# Product Change Notification

## 109782 - 00

**Change Notification #:** 109782 - 00  
**Change Title:** Intel® Server Accessory FXX25HDDCAR, PCN 109782-00, Product Design, 2.5 HDD Carrier Design is changed  
**Date of Publication:** January 18, 2010

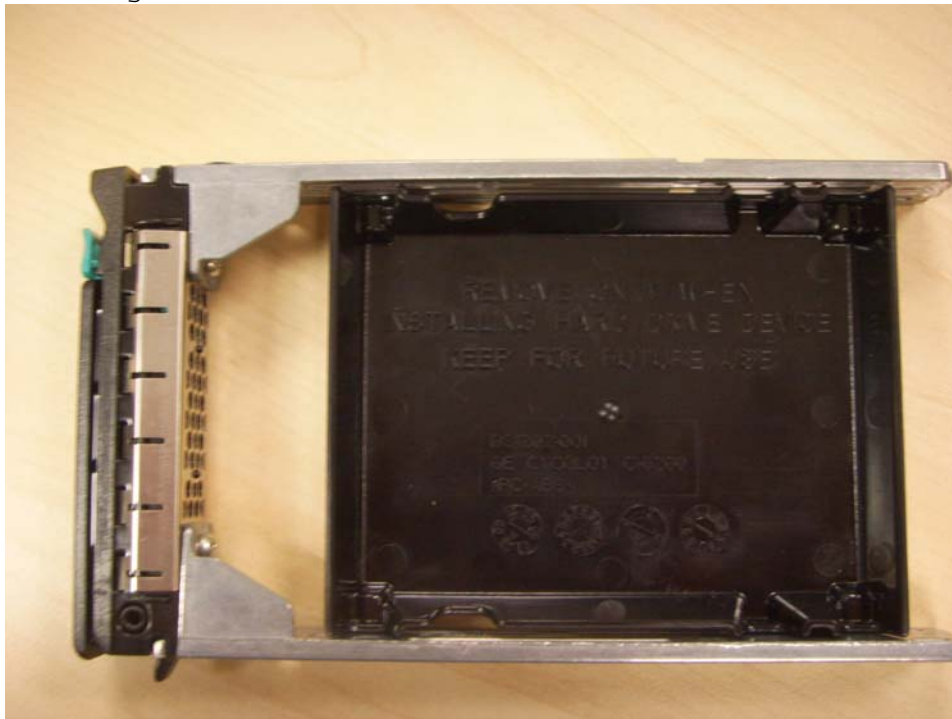
The 2.5 Inch HDD Carrier is changed to remove the Gusset plate from both the left rail and right rail. Please refer to the following photos to know the detail. The modification is to allow more hard disk models on Intel® Modular Server MFSYS25 which bundle this kind of hard disk carriers. This change does not impact any other Intel® chassis.
